# Staff Report

**Re:** Application for Lot 4 Section 6 Renfrew District, Plan VIP6253, with street address of 88 Lake Cowichan Road, for the following:

- 1) **Development Permit** in accordance with the Downtown, Uptown, Neighbourhood Centre, Tourism Areas and Commercial Development Permit Area (DPA 4) and Natural Hazard Lands –Wildfire Area (DPA 2) of the Official Community Plan. and
- 2) **Development Variance Permit** in accordance with the Zoning Bylaw.

The Town has received an application for construction of a 414 square metre commercial building at 88 Cowichan Lake Road.

**RTH ELEVATION**

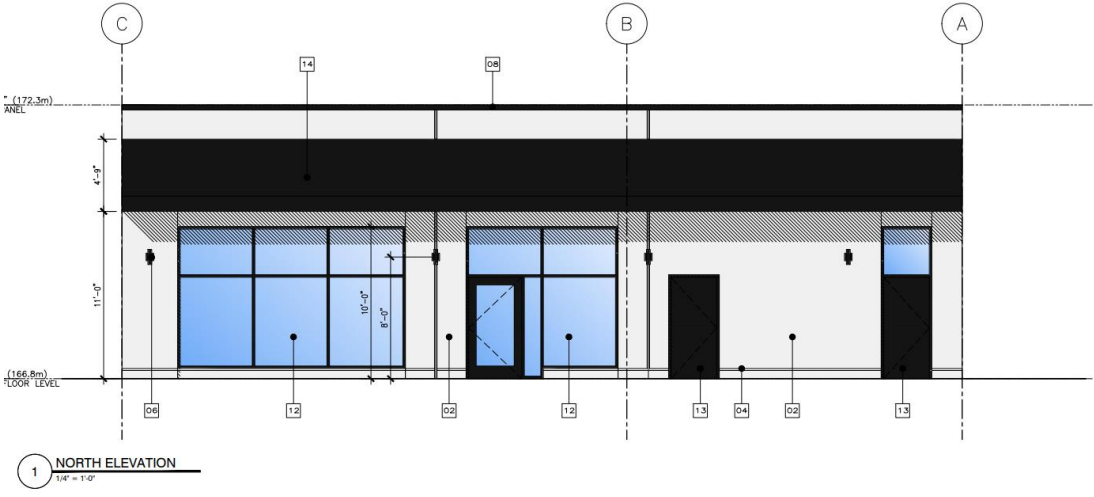
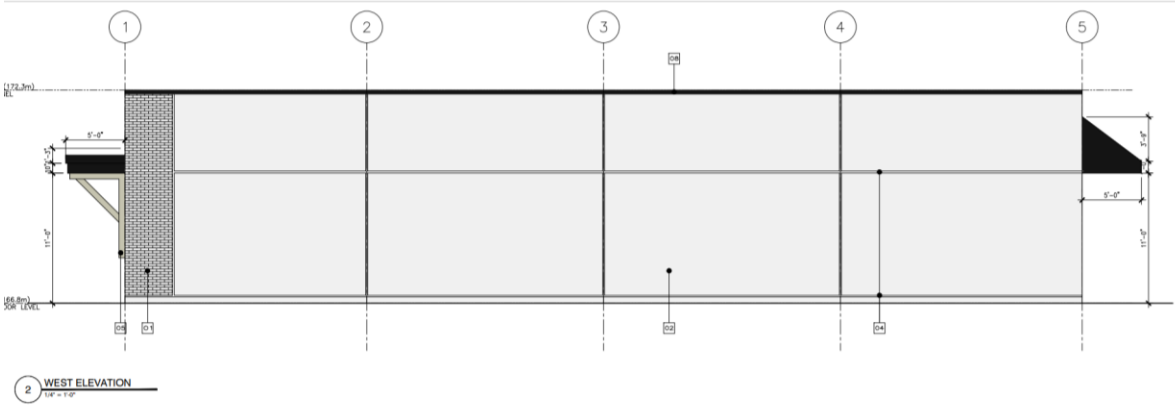
- **Comment:** *provides timber wood brackets*
- 5) Development shall generally reflect the bulk, mass, character, shape, and form of adjacent buildings and acknowledges architectural, design and historic features of the area.

- **Comment:** *overhang is a positive contribution*
- 6) Vary roof lines.
- 7) Extensively use natural materials for exterior finishing such as timber, board and battens, clapboard (hardiplank permitted), shingles stone, and brick.

- **Comment:** *overhang protects frontage on street*
- 10) Colours shall reflect the natural environment of the Cowichan Lake area. Primary and bright neon colours may only be used for trim and accents.

1 GARBAGE ENCLOSURE PLAN  
1/4" = 1'-0"

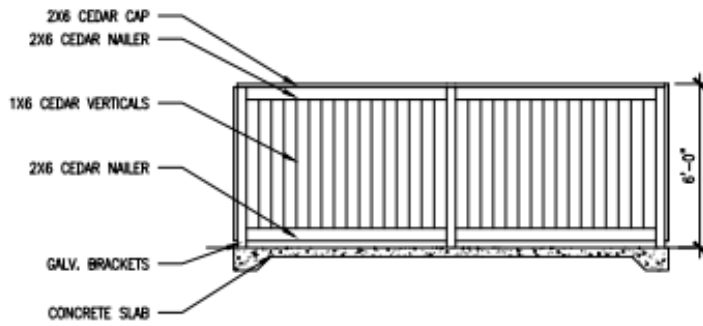
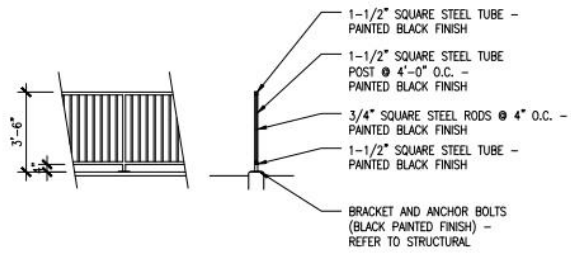
- **Comment:** *garbage enclosure is fenced*
- 14) Finish pedestrian and parking areas with hard surfaces such as concrete, asphalt, brick, stone, stone pavers, or similar materials.
